Road Safety Audit

Intersection Southern Ports Highway & Southend Access Road, Southend

May 2019

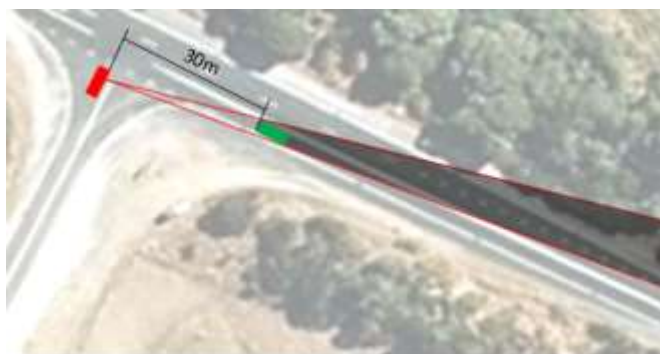
Crash data indicates that vehicles making right turn movements from Southend Access Road are responsible for the only casualty crash in the most recent five years of data (2013-2017) and another casualty crash in 2011. Both of these crashes were due to a driver of a vehicle turning right from Southend Access Road failing to give way to a northwest bound vehicle on Southern Ports Highway.

A vehicle turning from the main carriageway has minimal impact on sight distance to the southeast

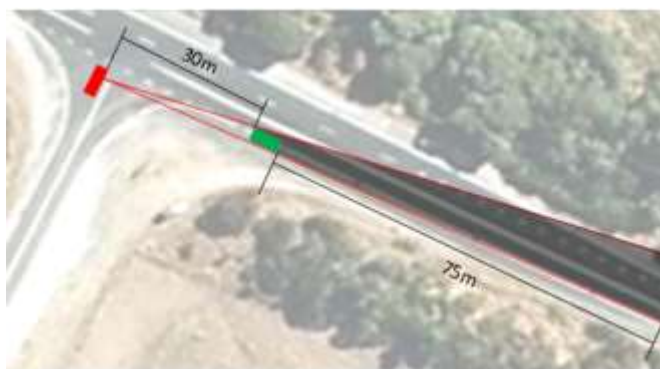
There are no obstructions to sight lines to the southeast from the holding position on Southend Access Road, and sight distance is substantial. It is possible for a vehicle turning left from Southern Ports Highway onto Southend Access Road to conceal the presence of through vehicles to a vehicle turning out of Southend Access Road as shown in the below diagrams.

It is of the auditor's opinion that installing a left turn lane as discussed in item 1 will provide greater awareness of the two northwest bound traffic movements through the intersection. It is reasonable to expect that all left turning vehicles will utilise the left turn lane, creating consistency with northwest bound movements through the intersection.

A vehicle straddling the edge line to turn left obscures the entire northwest bound lane behind the vehicle.

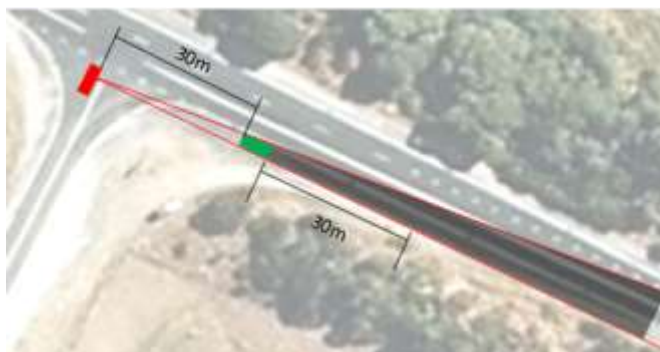
A vehicle turning left from the shoulder provides 30m of visibility behind the vehicle before completely obscuring the northwest bound lane.
